IMMINGHAM EASTERN RO-RO TERMINAL

Planning Statement (Incorporating Harbour Statement) Addendum

Document Reference 5.1.1

November 2023

Figure 2.1

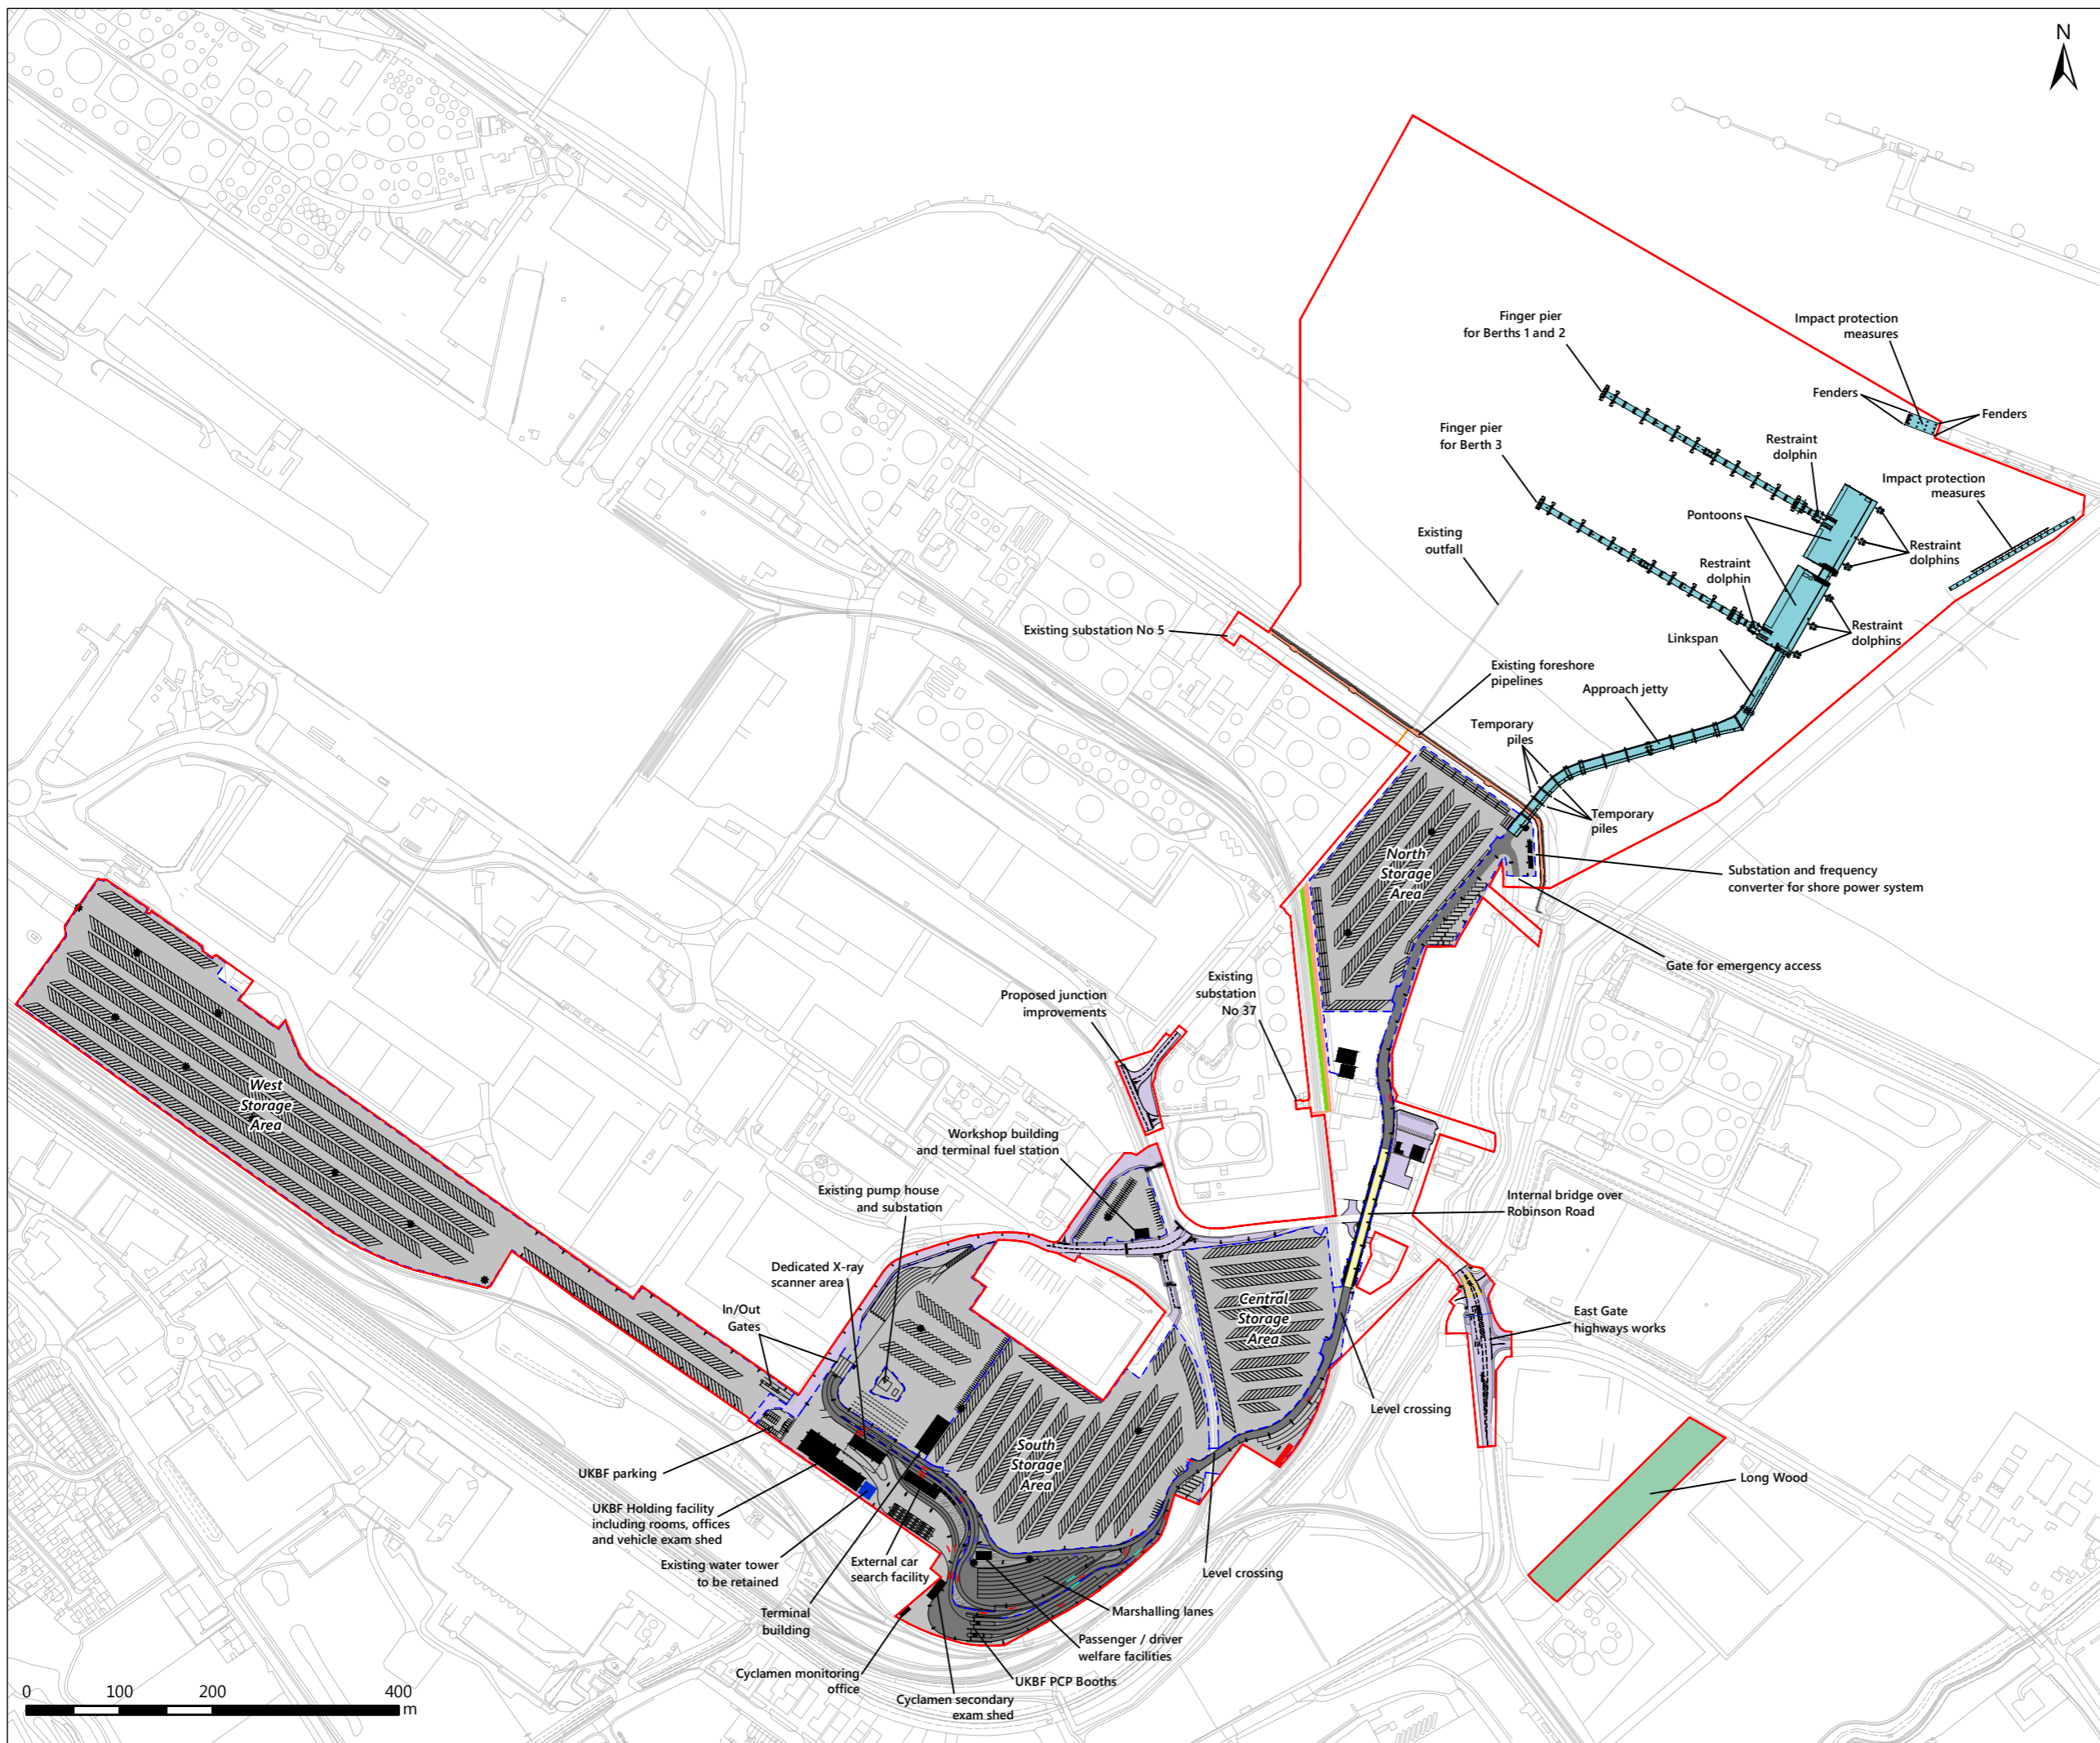
3.4 A revised figure is attached to this addendum (Figure 2.1) which illustrates the proposed development as amended by the Proposed Changes. This figure supersedes the previous Figure 2 of the Planning Statement. In addition, references to chapters of the ES should be taken to refer to the latest version of that Chapter as well as any corresponding part of the ES Addendum (application document 10.3.8).
